## Inspection Report

Permit Number:	C0250005
Inspection Type:	TECHNICAL
Inspection Date:	Tuesday, June 30, 2015
Start Date/Time:	6/30/2015 8:00:00 AM
End Date/Time:	6/30/2015 1:00:00 PM
Last Inspection:	Tuesday, June 16, 2015

Permittee: **ALTON COAL DEVELOPMENT LLC**

Site: **COAL HOLLOW**

**SEDIMENT IMPOUNDMENT POND 1 DETAILS**

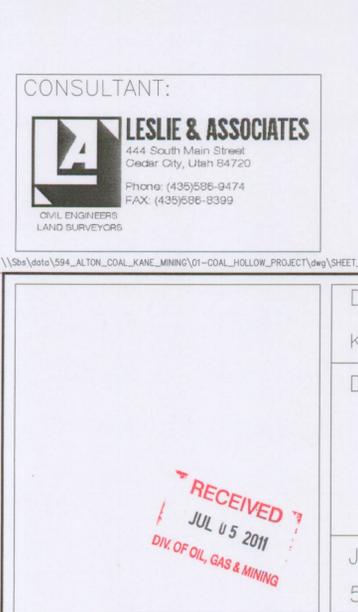
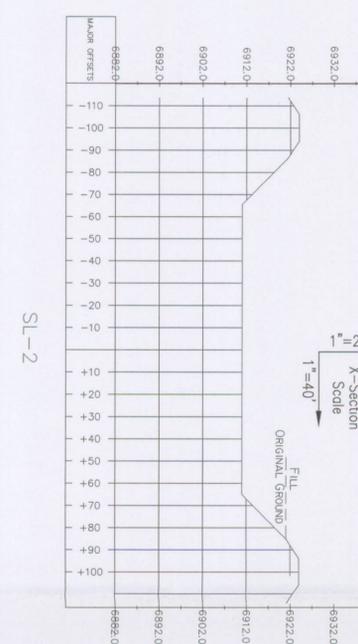
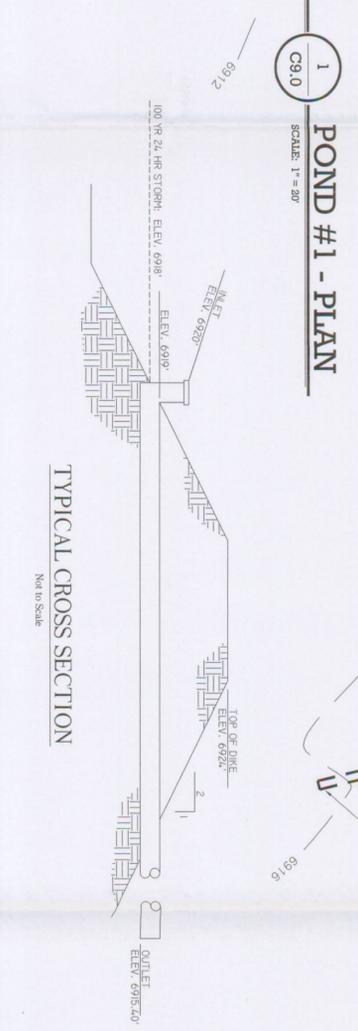
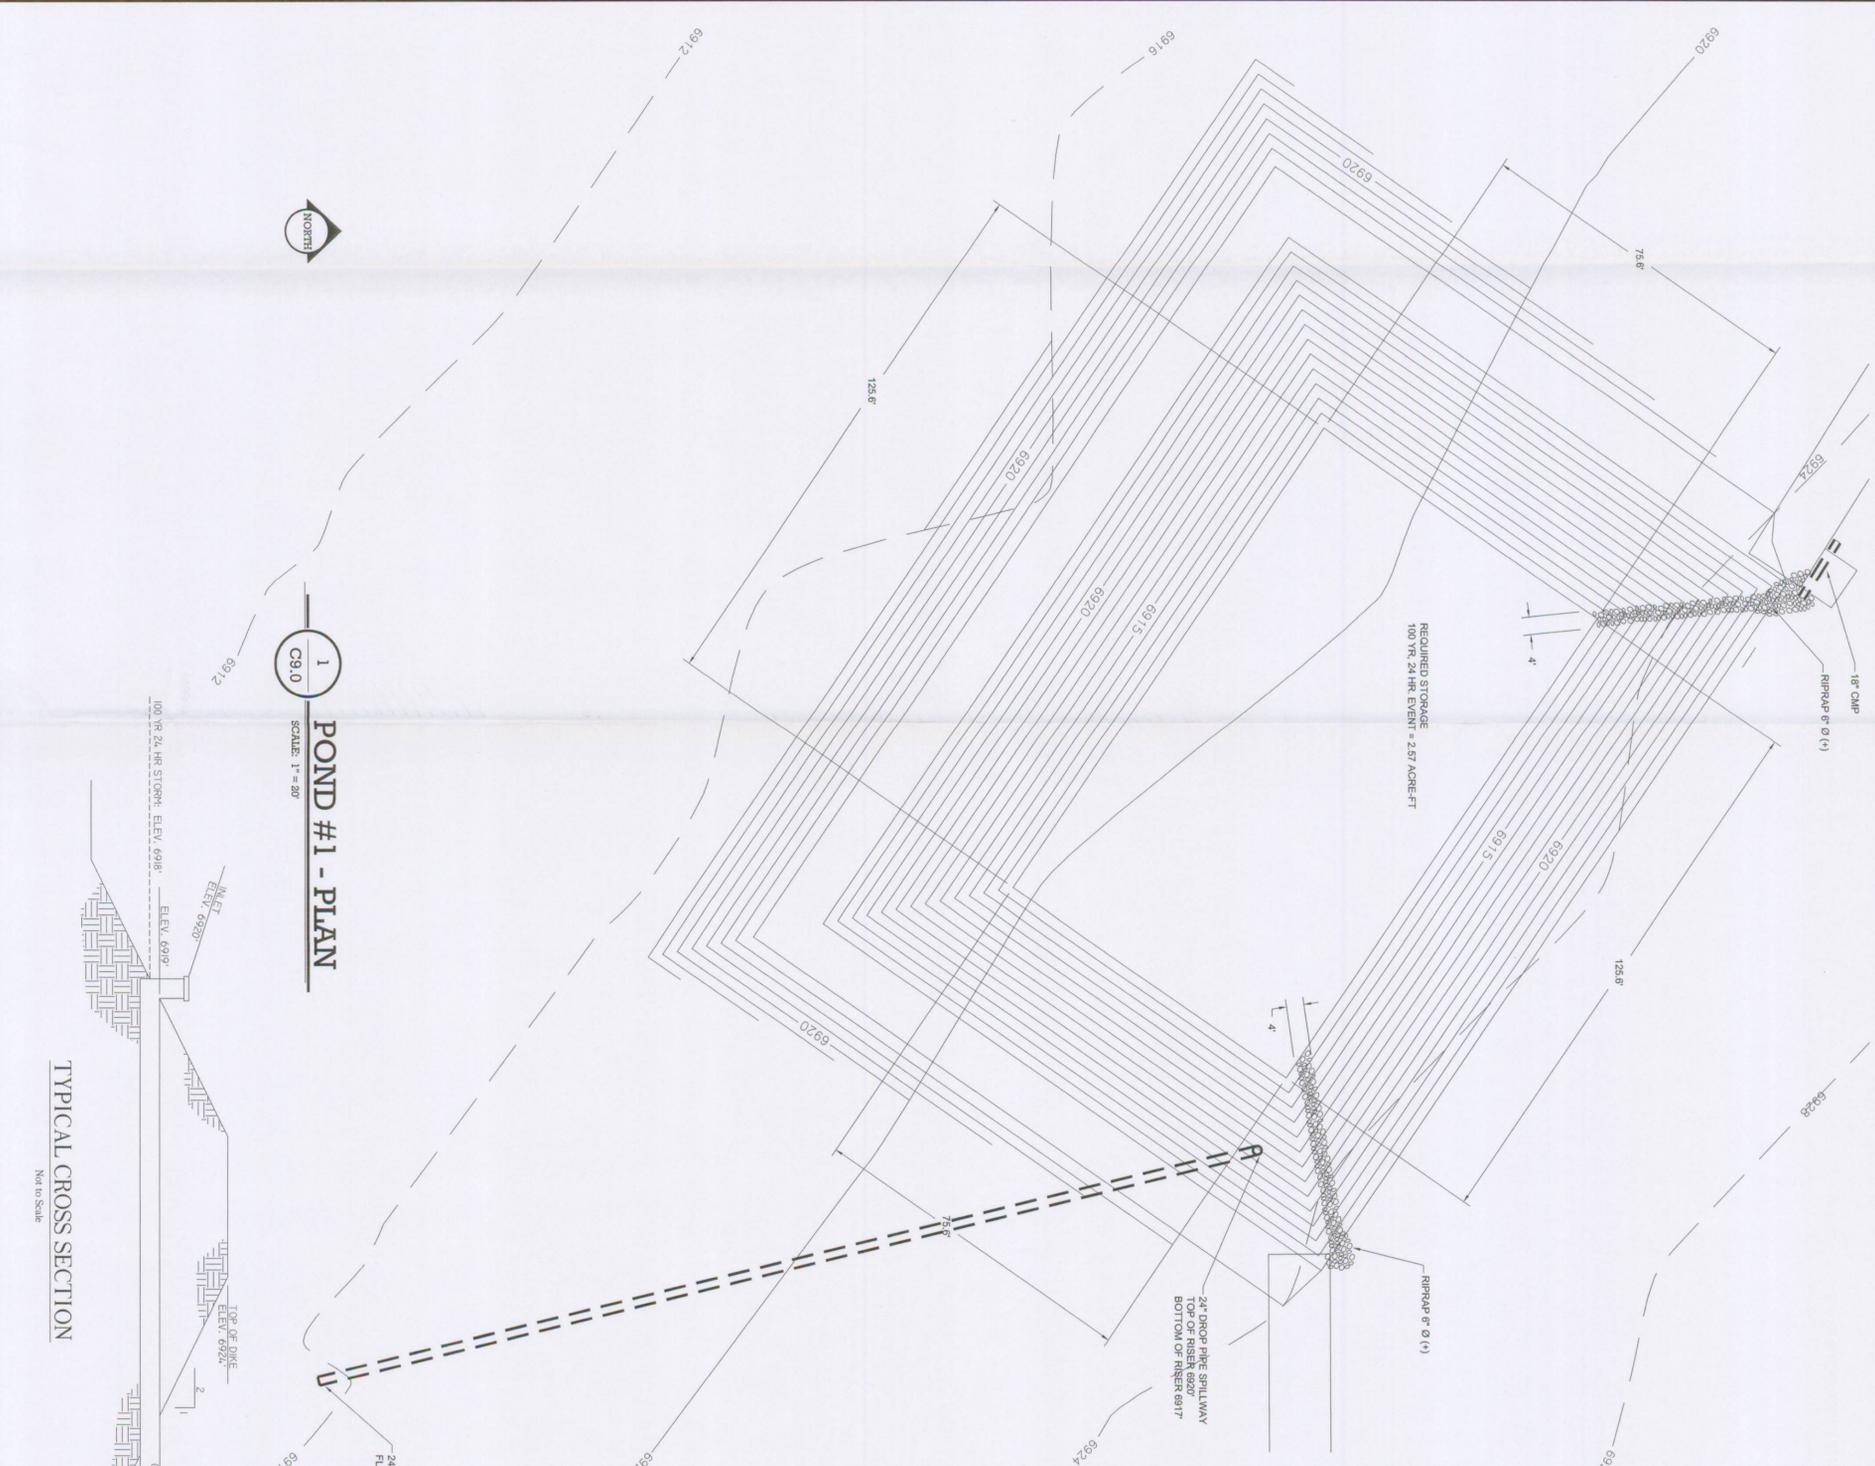
The Permittee stated that the second quarter certified pond and spoil inspections were completed the previous week and the final copies had yet to be received. The water truck was pulling water from Pond three at the time of the inspection. All ponds were inspected and found that the levels were relatively low with sediment levels below all the clean out marks. See Photos 12 for an example of water level height. Pond 1 has a gully on the east bank that still needs repairing along with riprap placed in the outlet. These maintenance tasks were required to be completed in the June 16 inspection by June 30. The Permittee submitted a design to modify the current inlet to Pond one. The Modification showed that the stated maintenance will be repaired during the construction of the modifications. The Pond one amendment was sent back deficient, Task 4894, on 6/9/15 and the Division has yet to receive the amended application. In the meantime, the maintenance needs to be completed before the rain season starts so riprap should be placed no later than 7/13/15, per as build drawing C9.0 for pond 1 attached. If the intent is to complete the required maintenance during the amendment's construction, Task 4894, the Permittee needs to resubmit the plans by 7/13/15. See photo 9.

The following is from previous inspection reports:  
Inspection 4219: As discussed during the inspection: the material dredged from pond 1 is now dried and should be removed from the pond embankment. The inlet to pond 1 should be rip rapped to accurately resemble the design by no later than Tuesday, June 30th. A large gully on the embankment of the pond 1 needs to be repaired prior to the next inspection. See also R645-301-742.123 for required maintenance on sediment ponds.
